Volvo Cars of North America, LLC  
Technical Engineering

Reference: VIDA, VSTG, RTJ 20261

**NOTE! THIS DOCUMENT SUPERSEDES THE PREVIOUS RETAILER TECHNICAL JOURNAL 17644 DATED 05-06-2009. The chassis numbers in the header have been updated. PLEASE UPDATE YOUR FILES.**

NOK

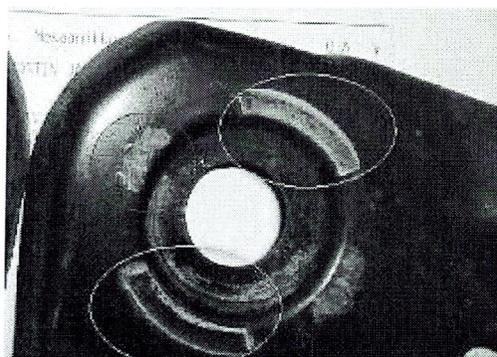
A customer may also complain of a groaning noise from the front suspension of the vehicle, especially when turning or driving over a speed bump. The root cause may be a rubbing conflict between the front subframe rear bushing and the support plate. Refer to the picture below to the left for abnormal contact. Contact between the bushing and the support plate according to the green areas in the picture below to the right, is normal.

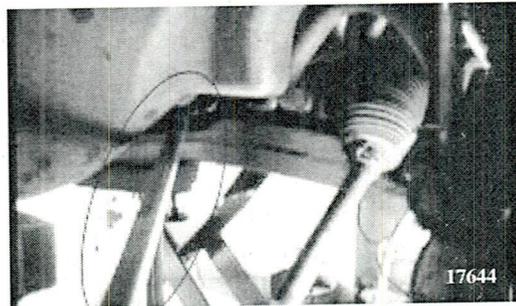
Test 1: Disconnect the front anti-roll bar link on both sides. If the noise is gone, it indicates that the noise could be coming from the front subframe, rear bushings.

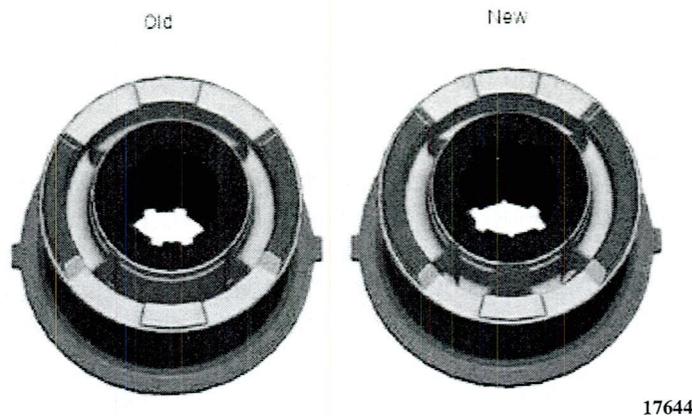
Test 2: Use a pry bar to move the subframe (see picture below) and listen for the noise.

If the bushing show signs of wear or if the cause of the problem is that the bushing is not in the correct position in the subframe metal tube, replace the subframe bushing according to VIDA, RTJ 20261, and the details on page 3. The new subframe bushing will have a different interface (wider contact area) with the support plate. See the photo below.
